TSB # 19-039
LCI Awning Circuit Protection

Technical Service Bulletin Notification TSB #19-039

AWNING CIRCUIT PROTECTION- AUTO RESET BREAKER

Bulletin Type:	Technical Service Bulletin TSB
Bulletin #:	19-039
Job Code:	9801443
Flat Rate:	.3 hour

FIG 1:

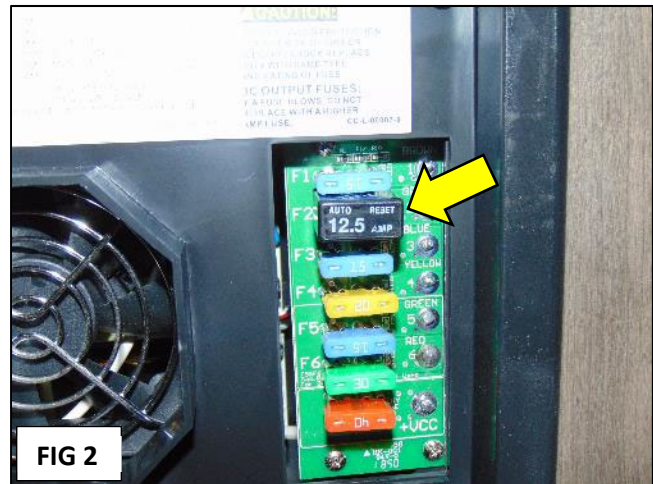
- For most models (Jayco, Starcraft, Highland Ridge) the awning fuse will be located in the Load Center.
- Open the Load Center and the awning fuse will typically be located in the row of fuses (arrow).

FIG 2:

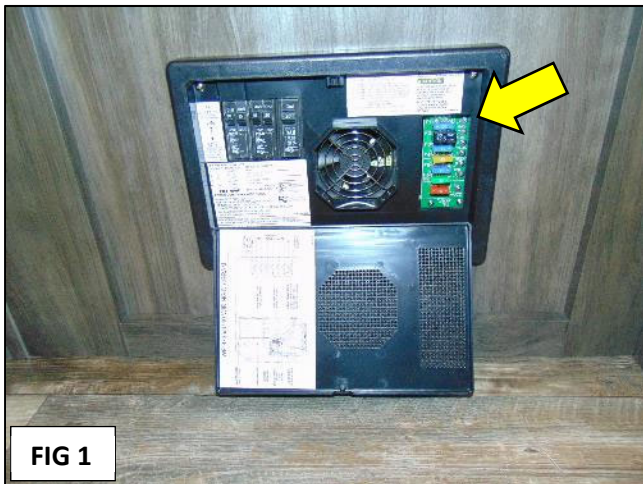
- Check the label in the Load Center which will show where the awning fuse is located.

NOTE: the awning fuse will not be in the position shown in this photo for EVERY model.

In this photo the blue 15A fuse was already removed and replaced.

- Pull out the blue 15A fuse for the power awning.
- Replace the blue 15A fuse with the 12.5A auto reset breaker.
- Close the Load Center

FIG 3:

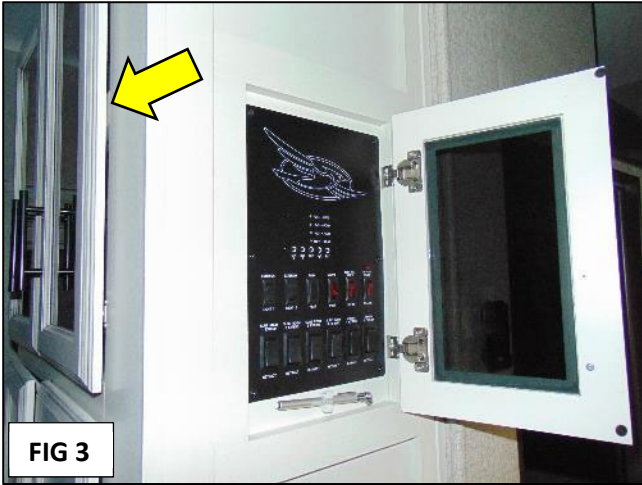
- The fuse is located in the cabinet behind the Command Center Panel (arrow).

- Remove the false panel to access the fuse location (arrow).
- There are typically 4 screws(one in each corner) to remove.

FIG 5:

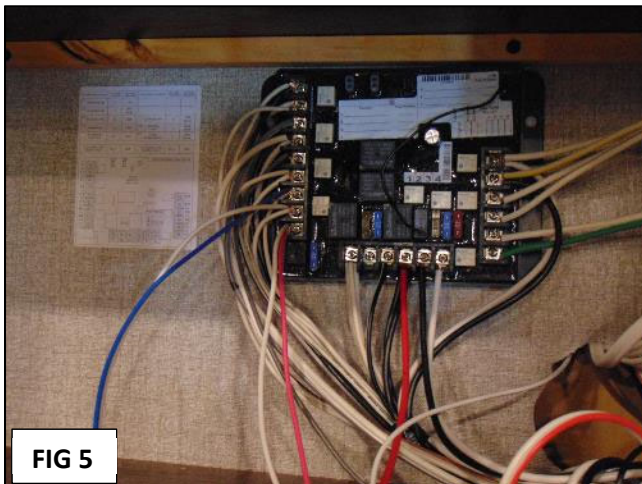
- Inside the cabinet there is a fuse location chart and a printed circuit board.

- Reference the location chart upper part which will show which fuse is for the awning (outlined).

FIG 7:

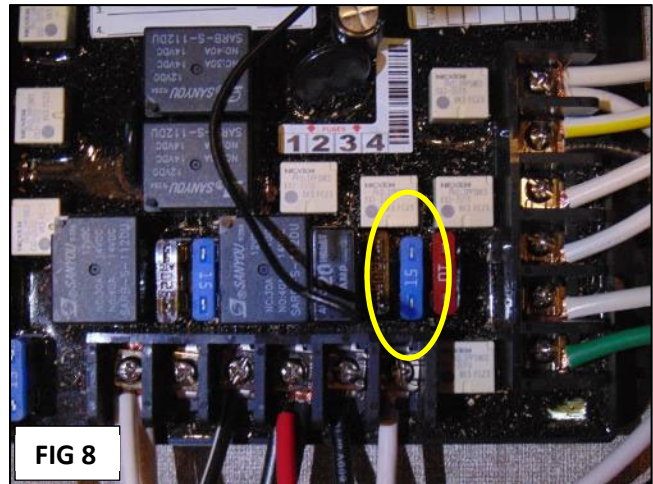
- Lower part of the chart shows the awning fuse location (arrow).

FIG 8:

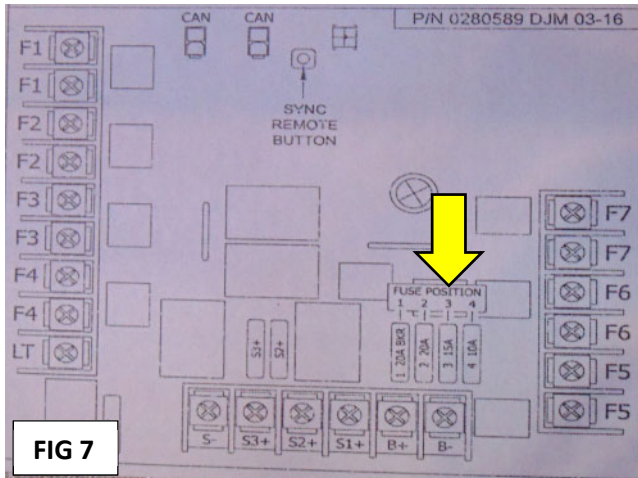
- Pull the blue awning 15A fuse (circled) out, and replace with the auto reset 12.5A breaker.

Replace the false panel using the 4 screws removed.

FIG 9:

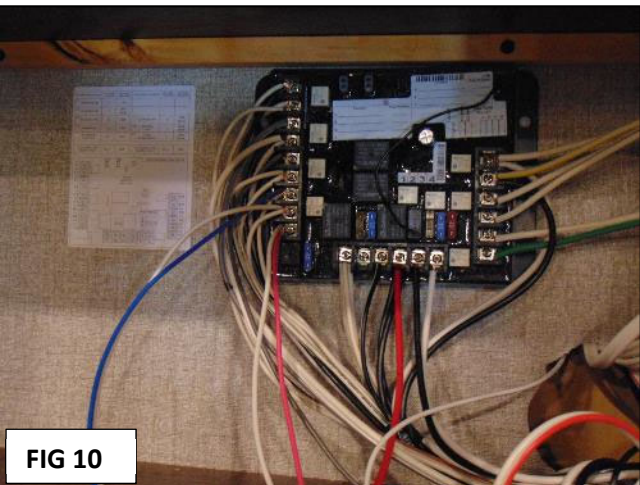
- Remove the Command Center panel (6 screws)

FIG 10:

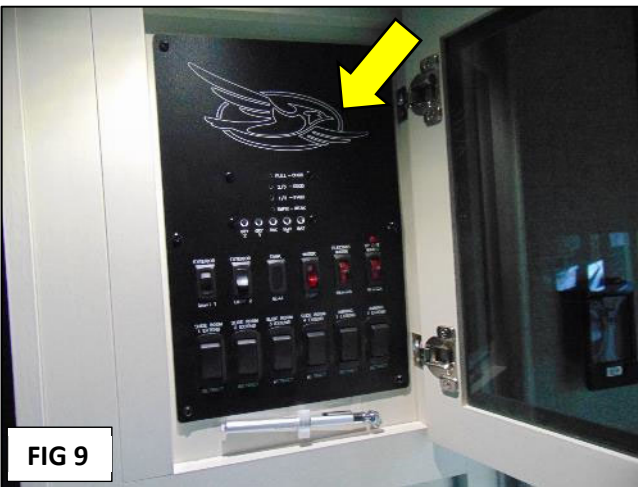
- The fuse is located on the printed circuit board behind the Command Center panel.

- Reference the location chart upper part which will show which fuse is for the awning (outlined).

FIG 12

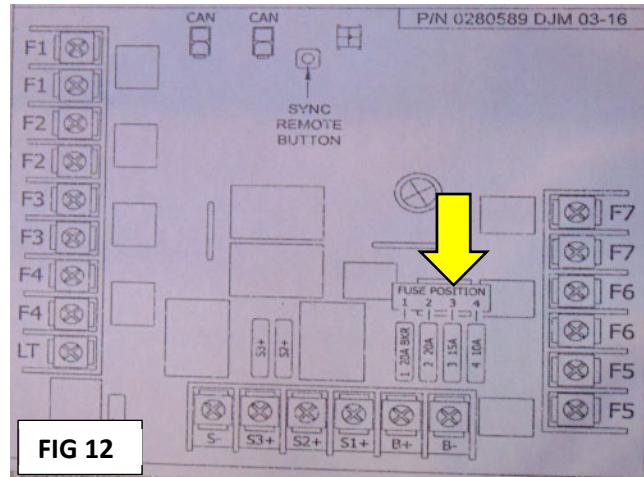
- Lower part of the chart shows the awning fuse location (arrow).

FIG 13

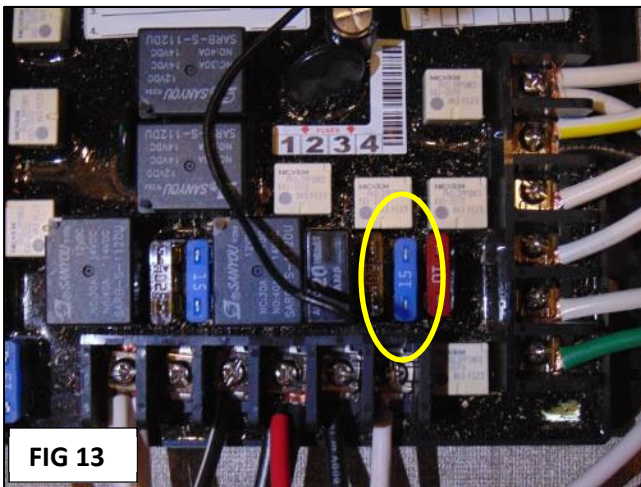
- Pull the blue awning 15A fuse (circled) out, and replace with the auto reset 12.5A breaker.

Replace the Command Center panel using the 6 screws removed.
